FINAL DRAINAGE REPORT
FOR
STERLING RANCH EAST FILING NO. 2
&
FOURSQUARE AT STERLING RANCH EAST FILING NO. 1

October **2023**

Job no. 2183.23
PCD File # SF2236 & SF2237

INLET IN A SUMP OR SAG LOCATION

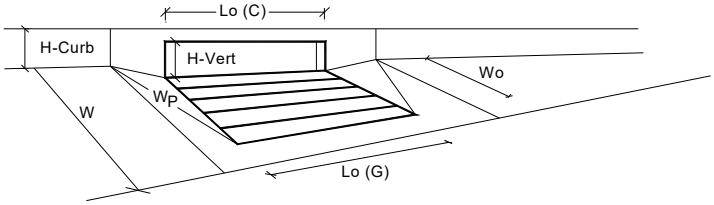
Include scenario for this inlet that includes that overtopping from DP5 to show what happens. Include small discussion within report. (Can inlet still function, how deep does flow get in roadway, etc)

DETENTION BASIN STAGE-STORAGE TABLE BUILDER

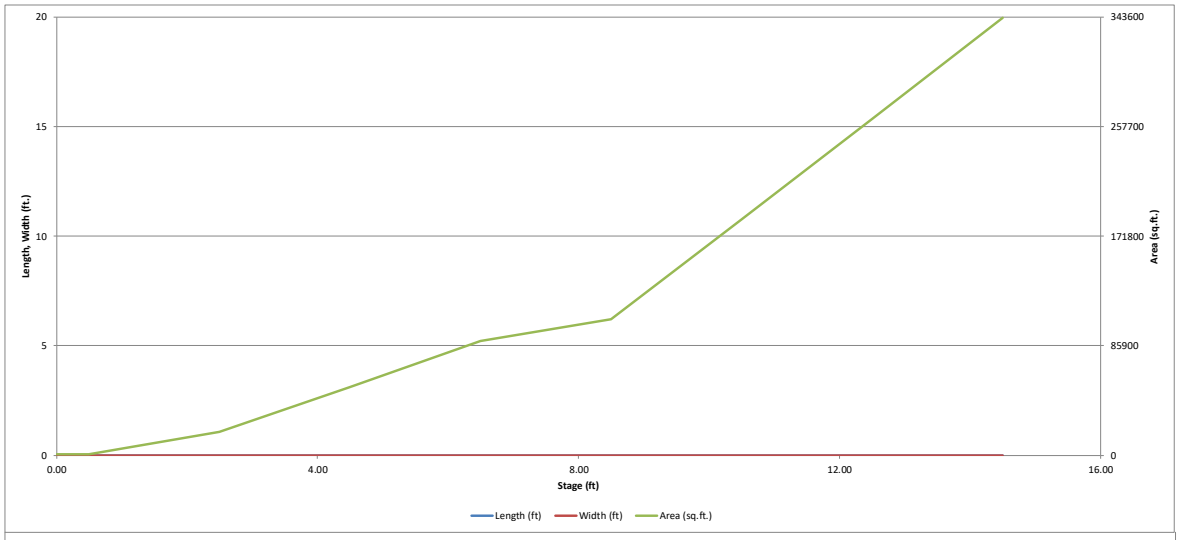
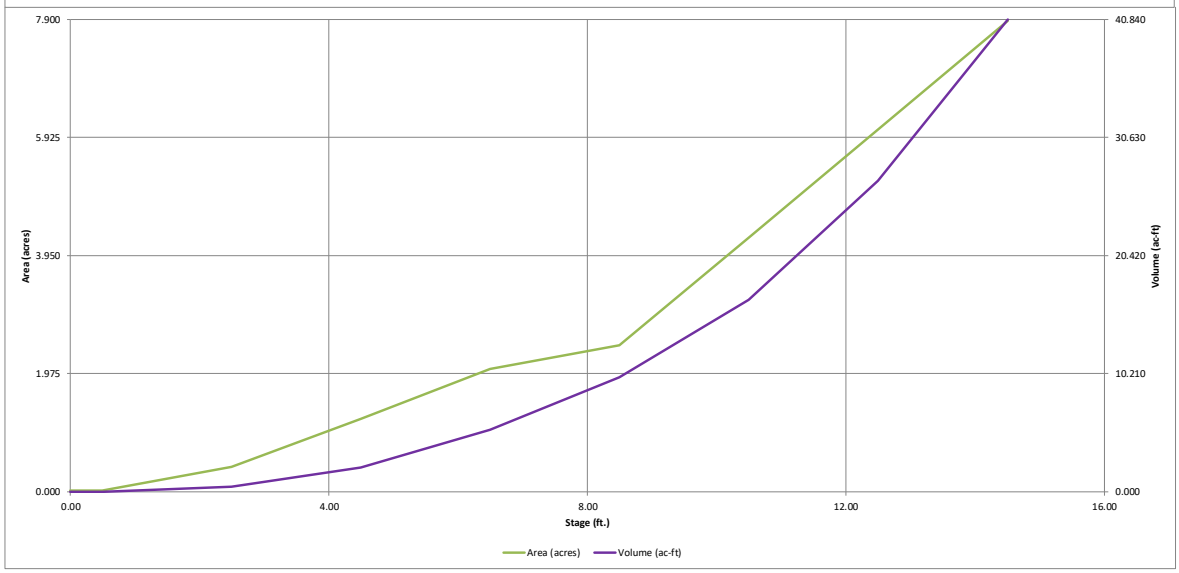
Pond detail sheet 27 in CDs shows 4:1 side slopes. Please reconcile between report and drawings to show same slope.

Now shown as 4:1 on CDs Sht 27 detail. Was 6:1 on detail with the last submittal
